Product Change Notice (PCN)

PCN Number: PCN-0462303R-01

Product(s) Affected: TB003V-500 Series. Inclusive of both screw types and colors.
Screw types: Phillips and Slotted
Colors: BE/Blue, GR/Green, OR/Orange, YL/Yellow, GY/Gray and BK/Black

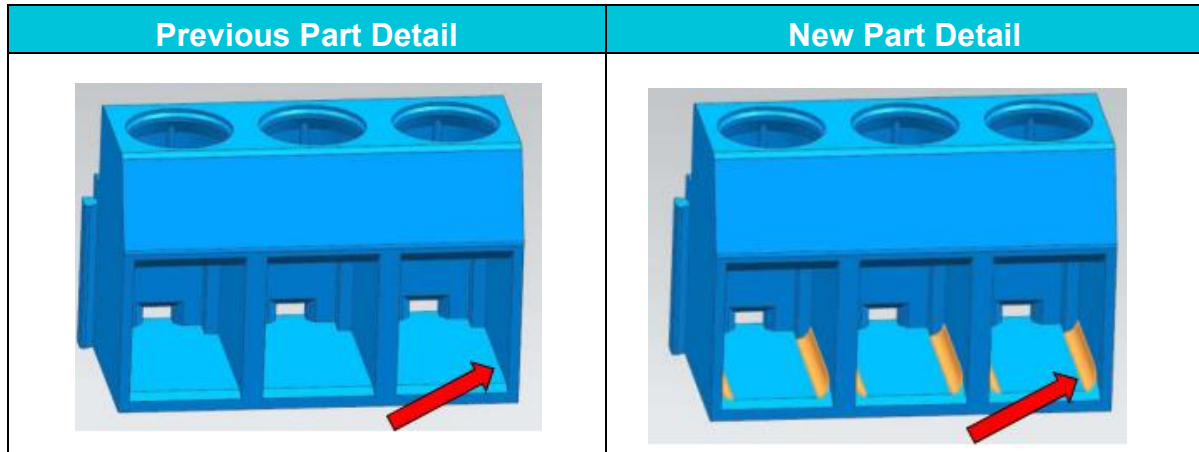
Reason(s) for Change: **Improve structural strength**

Description of Change: *Modified Housing. Add a 0.5mm thickness chamfer on the place which is right angle chamfer in the lower corners, as indicated in orange on the image below.*
